**SUBDIVISION,
PLANNED UNIT DEVELOPMENT, &
PLANNING APPROVAL STAFF REPORT****Date: December 18, 2014**

<u>NAME</u>	Emmanuel Subdivision
<u>SUBDIVISION NAME</u>	Emmanuel Subdivision
<u>LOCATION</u>	1962, 2000 and 2008 Dr. Martin Luther King, Jr. Avenue (Northeast and Southeast corners of Dr. Martin Luther King Jr. Avenue, extending to the West side of Vine Street)
<u>CITY COUNCIL DISTRICT</u>	District 2
<u>PRESENT ZONING</u>	R-1, Single-Family Residential District
<u>AREA OF PROPERTY</u>	3 lots / 3.3 ± acres (Subdivision) 2 lots / 2.94 ± acres (PUD and Planning Approval)
<u>CONTEMPLATED USE</u>	Planning Approval to allow the expansion of an existing church school in a R-1, Single-Family Residential District, Planned Unit Development approval to allow multiple buildings on a single building site and off-site parking, and Subdivision approval to create three legal lots.
<u>TIME SCHEDULE FOR DEVELOPMENT</u>	Not specified.
<u>ENGINEERING COMMENTS</u>	<p>Subdivision: The following comments should be addressed prior to submitting the FINAL PLAT for acceptance and signature by the City Engineer:</p> <p>A. Provide all of the required information on the SUBDIVISION PLAT (i.e. signature bloc

SITE PLAN

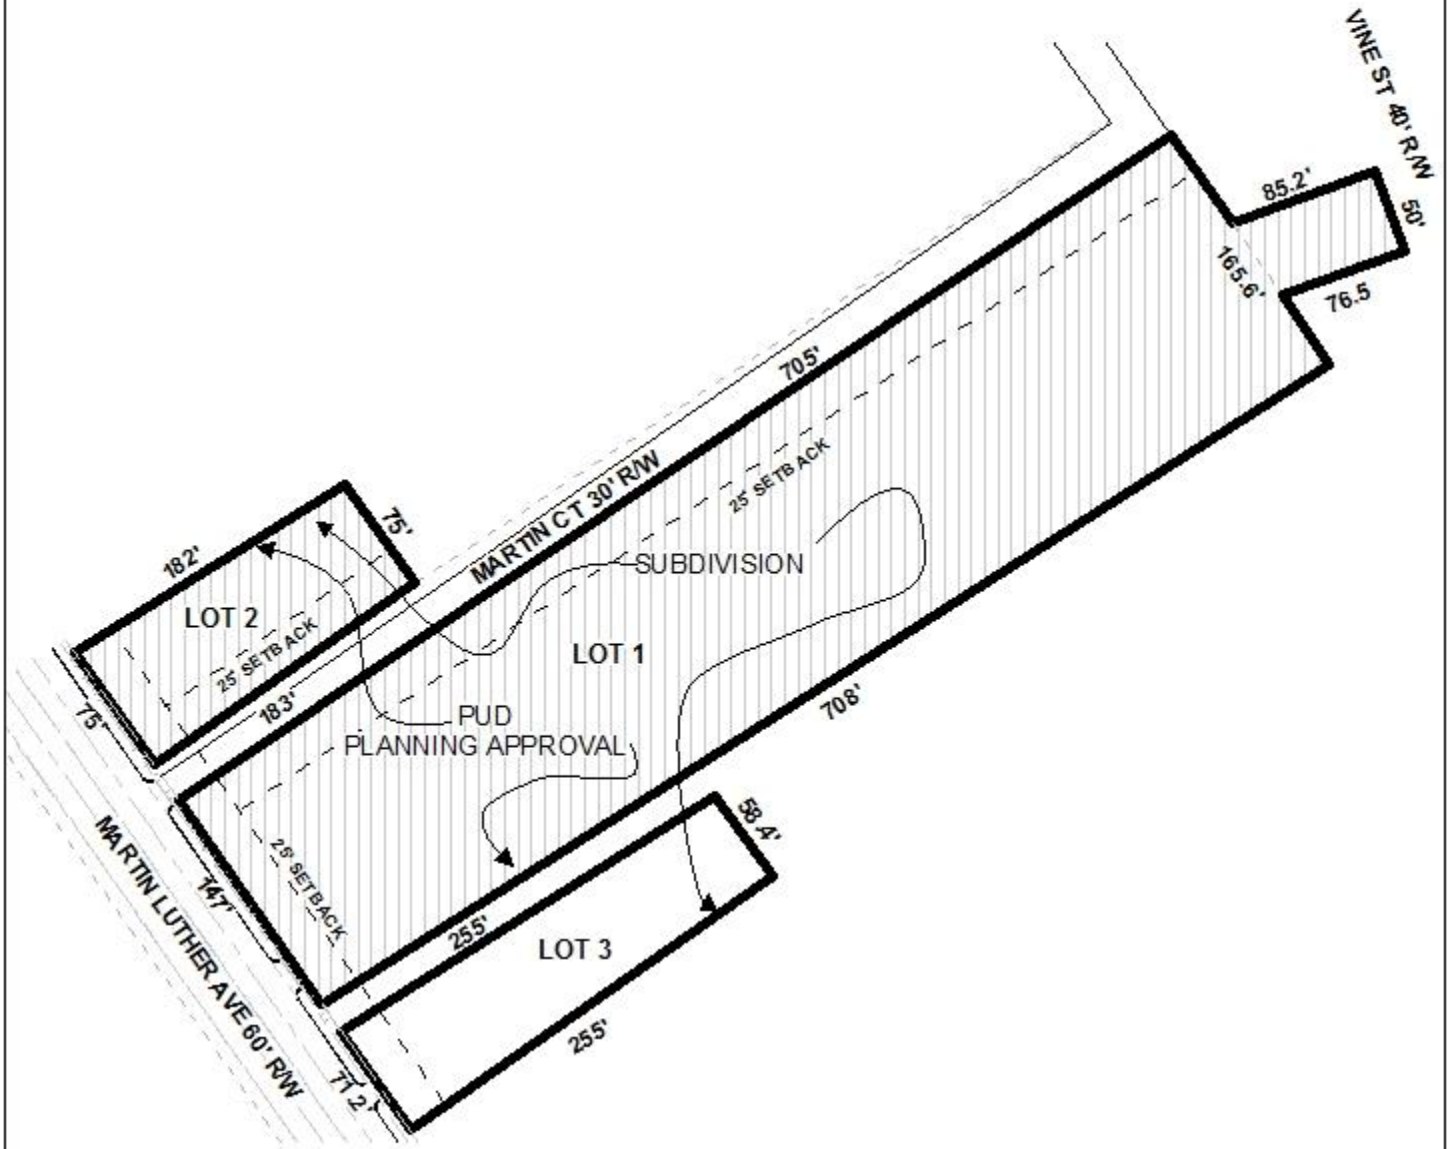
As mentioned, the site plan illustrates 5 parallel parking spaces within the existing right-of-way, which should be eliminated. Compliance with Traffic Engineering comments should also be depicted on the revised site plan.

In reference to tree and landscaping compliance, the proposed landscaping on the proposed Lot 2 is compliant in regards to trees and landscaping; however, the proposed 3' high hedge row should also be extended and illustrated along the frontage of Martin Court on the revised site plan. Landscaping data is listed on the site plan for the proposed Lot 1; however, full compliance with the tree and landscaping requirements of the Zoning Ordinance will not be required until the time of development if the total gross floor area of the site is increased and/or decreased by at least 50% of the existing buildings' footprint.

The site plan depicts a 6' high wooden privacy fence on the proposed Lot 2 to be used as a residential buffer; however, the site plan should be revised to depict all proposed fencing not to exceed 3' in height within the 25' minimum building setbacks of Martin Court and Dr. Martin Luther King, Jr. Avenue.

The site plan illustrates an existing dumpster pad and enclosure within the existing parking lot on the proposed Lot 1. Staff recommends eliminate the 2 adjacent parking spaces on either side of the dumpster. In the event the dumpster is relocated, the site plan would be revised to illustrate any proposed dumpster in compliance with Section 64-4.D.9. of the Zoning Ordinance. If the site layout can effectively accommodate the existing dumpster, full compliance with Section 64-4.D.9. would not be required at this time.

- 1) Revision of the site layout to reflect compliance with Traffic Engineering comments and to show the removal of the 5 parallel parking spaces and 2 spaces on either side of the existing dumpster;

- 2) Revision of the parking data to illustrate the correct number of existing and proposed parking spaces;
- 3) Illustration of a 3' high hedge row along Martin Court on the proposed Lot 2;

- 4) Depiction of the correct dimensions/square footage of the proposed modular building;
- 5) Placement of a note on the site plan stating that proposed privacy fencing is not to exceed 3' in height within the 25' minimum building setbacks of Martin Court and Dr. Martin Luther King, Jr. Avenue;
